FAQ Number 07-0038

FAQ Title Lessons learned on Multiple Spurious Operations

Plant: Harris

Date: September 20, 2007

Figure XX – Multiple Spurious Operations – Transition Resolution Process

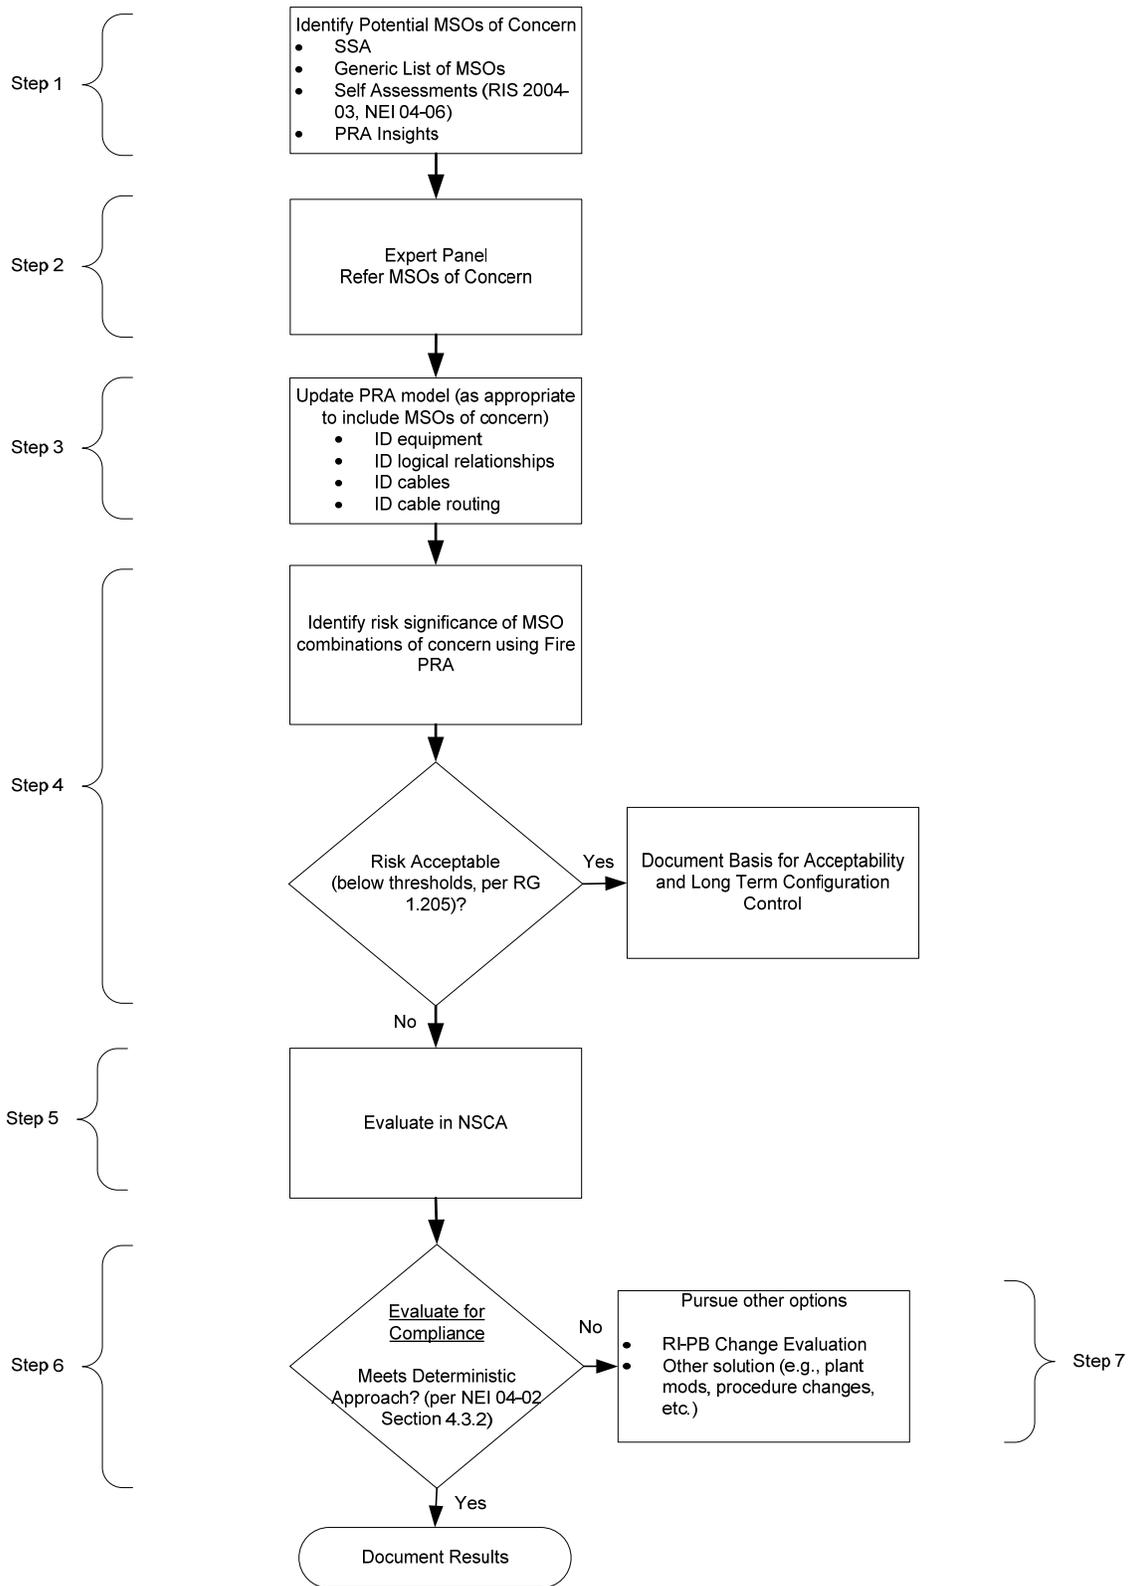
The approach outlined in Figure XX below is one acceptable method to address fire-induced multiple spurious operations. This method uses insights from a Fire PRA that meets the requirements of Regulatory Guide 1.205, Revision 0.

Step 1 - Identify potential MSOs of concern. Information sources that may be used as input include:

Step 2 - Conduct an expert panel to assess plant specific vulnerabilities (e.g., per NEI 00-01, Rev. 1 Section F.4.2). The expert panel should focus on system and component interactions that could impact nuclear safety. This information will be used in later tasks to identify cables and potential locations where vulnerabilities could exist.

Step 3 – Update the fire PRA model to include the MSOs of concern. This includes the:

Step 4 – Identify the risk significance of MSOs of concern.

Step 5 – Evaluate in the Nuclear Safety Capability Assessment (NSCA)

Step 6 – Evaluate for Compliance

Step 7 – Resolution Options

Figure YY – NEI 04-02 Section B.2.1 Change in Risk Criteria due to MSOs (Change in CDF Only Shown)

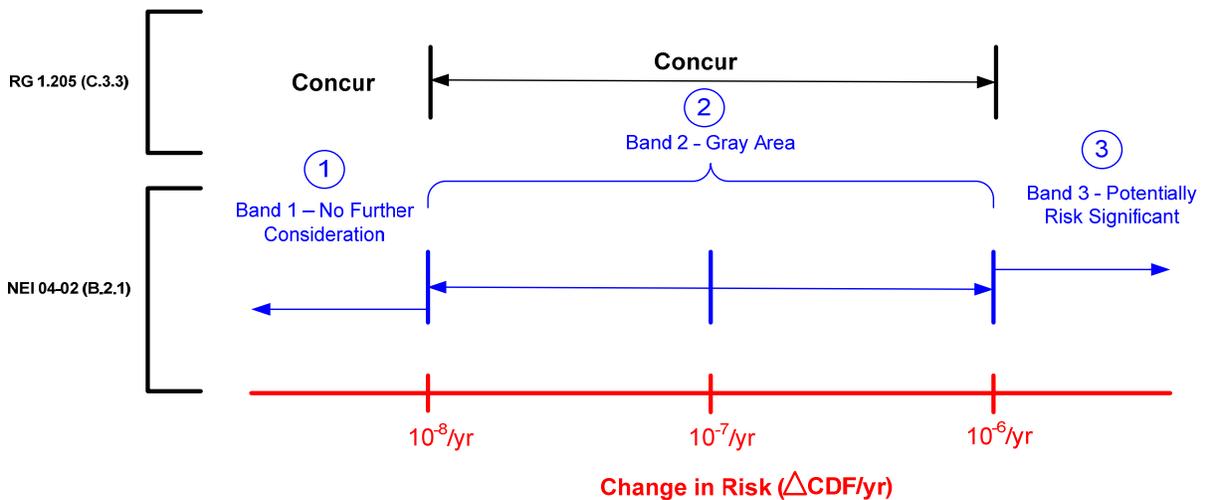
Determine if the risk significance of the MSO warrants additional review / action. The following table and figure provide a summary of risk thresholds that have been reviewed and found acceptable by the NRC for addressing MSOs. If surrogate approaches are used to focus on higher risk scenarios, a CDF value of 1E-08/yr prior to operator response to address the fire-induced spurious operation (LERF value of 1E-09/yr) should be used as a threshold value for the scenarios, consistent with the values for MSOs previously found to be acceptable. Refer to Table XX and Figure YY.

Potential MSOs of concern below the screening threshold (band 1 of Figure YY) do not require further evaluation. The review that was performed should be documented for configuration control. This documentation should include a disposition of items recommended by the expert panel for additional review.

Figure ZZ – RG 1.205 Change in Risk Criteria due to MSOs (Change in CDF Only Shown)

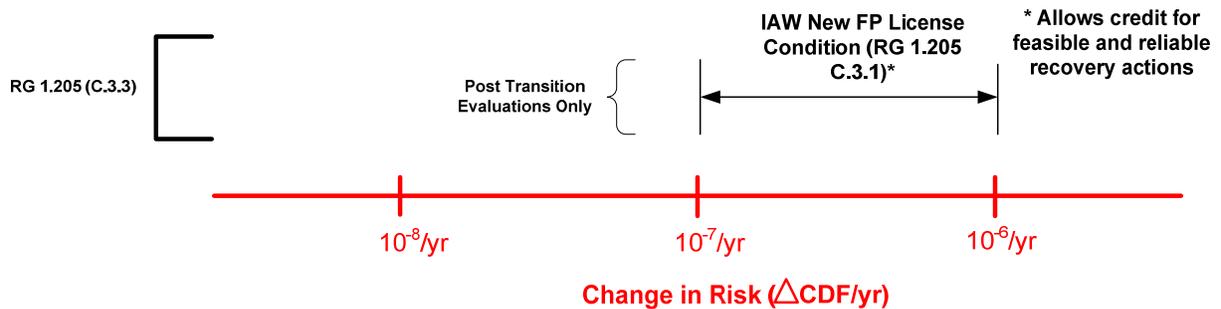
<u>Ref.</u>	<u>ΔCDF</u>	<u>ΔLERF</u>	<u>Characterization</u>	<u>Action</u>
<u>RG 1.205 (C.3.3 and C.3.1)</u>	<u><1E-06/yr but ≥1E-07/yr</u>	<u><1E-07/yr but ≥1E-08/yr</u>	<u>Post transition</u> <u>See Figure ZZ</u>	<u>Post-transition – Process in accordance with FP license condition (RG 1.205 – C.3.1)</u> <u>Allows risk increase to consider credit for feasible & reliable recovery actions.</u>
